Bala generating station: Creates risks to the Township

Inadequate public safety measures

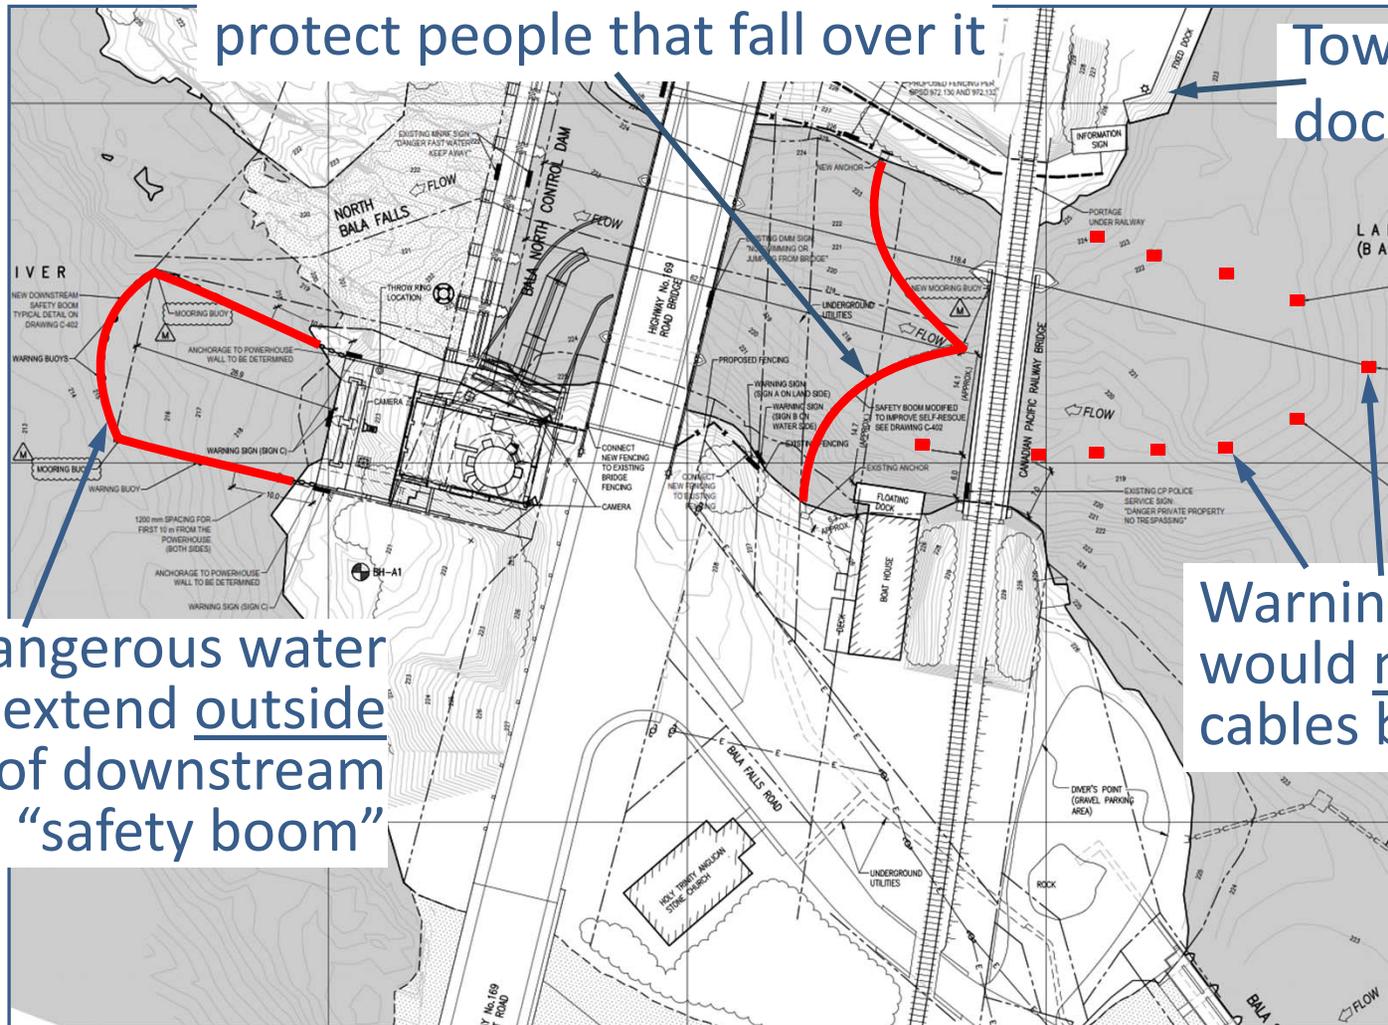
Upstream “safety boom”
would tip canoes, and not
protect people that fall over it

Warning signs
would not have
cables between

Dangerous water
would extend outside
of downstream
“safety boom”
